DATE ISSUED	March 5, 2012	ADDENDUM #	1
ENGINEER	Engineering Technologies, Inc. 825 M Street, Suite 200 Lincoln, NE 68508	PROJECT	SCC Beatrice Campus Ford Hall - HVAC Replacement
		ETI PROJECT #	2011-033

**ADDENDUM:**

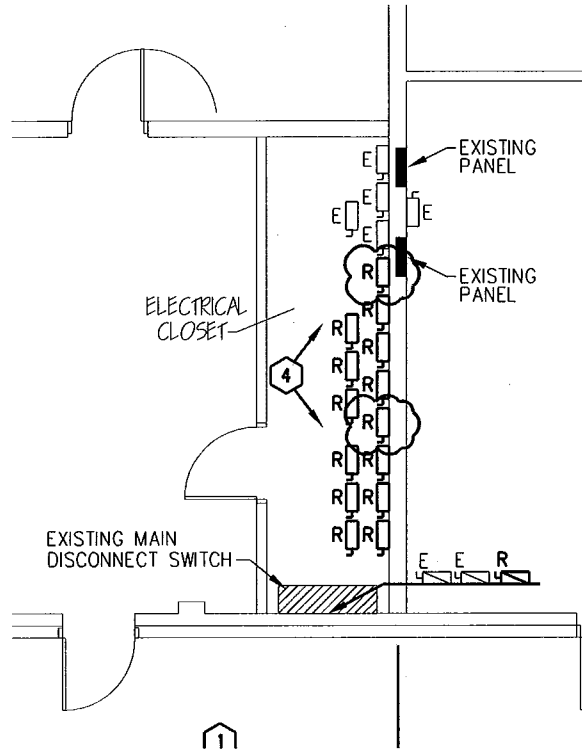
1. Sheet E1.1 First Floor Plan – Electrical Demolition
  - A. See drawing Sheet E1.1, Attachment No. 1E, dated 02/22/12 for removal of existing disconnects.
2. Sheet E2.1 First Floor Plan – Electrical
  - A. See drawing Sheet E2.1, Attachment 1E, dated 02/22/12 for changes to locations of Panels “MD”, “A”, “B”, & “C”.
3. Sheet E3.1 Schedules, Symbols, & Specifications
  - A. See drawing Sheet E3.1, Attachment 1E, dated 02/22/12 for changes to electrical riser diagram.
  - B. Air Handling Unit AHU-5, installation shall be completed as part of Phase 1 construction..

- 4. SEE ELECTRICAL DEMOLITION RISER DIAGRAM ON SHEET E3.1 FOR FURTHER DETAIL.
